DONAGHY / VERILLA
ADDITION PROPOSAL
1208 WASHINGTON AVE.
PORTLAND
 1/4" = 1'-0"

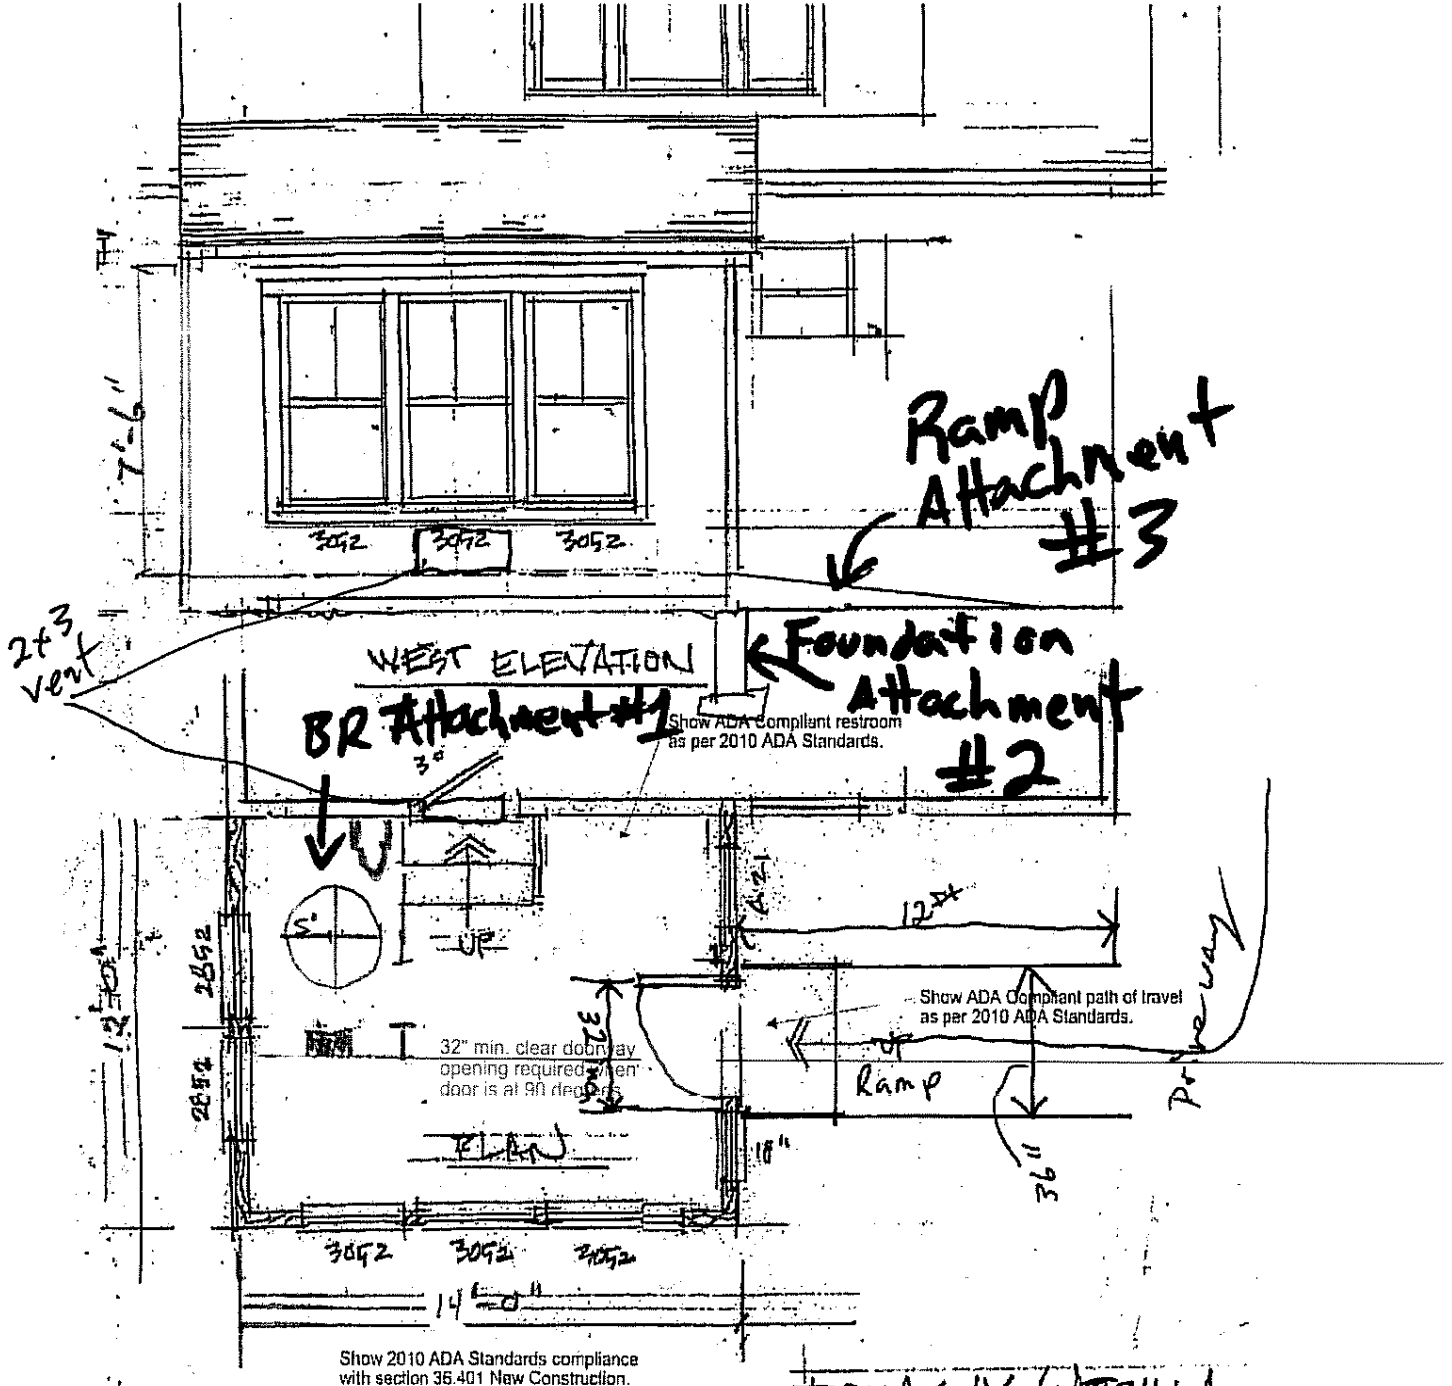
Show 2010 ADA Standards compliance with section 36.401 New Construction.

Please provide a section view drawing with the following information:
 Footing dimensions and depth below grade.
 Foundation damp proofing and drainage.
 Crawl space venting sizes/locations.
 Anchor bolt size and spacing.
 Joist, stud and rafter spacing.
 Framing connections and fastener schedule.
 Sheathing (floor, roof, wall) span ratings and thicknesses.

Please provide the following information on current drawings:
 Door/window header sizes/spans and number of jack studs.
 Insulation R-values for foundation, floor, walls and roof.
 Door/window U-values.
 Safety glazing locations.
 Stair riser and tread dimensions.
 Handrail locations and heights.
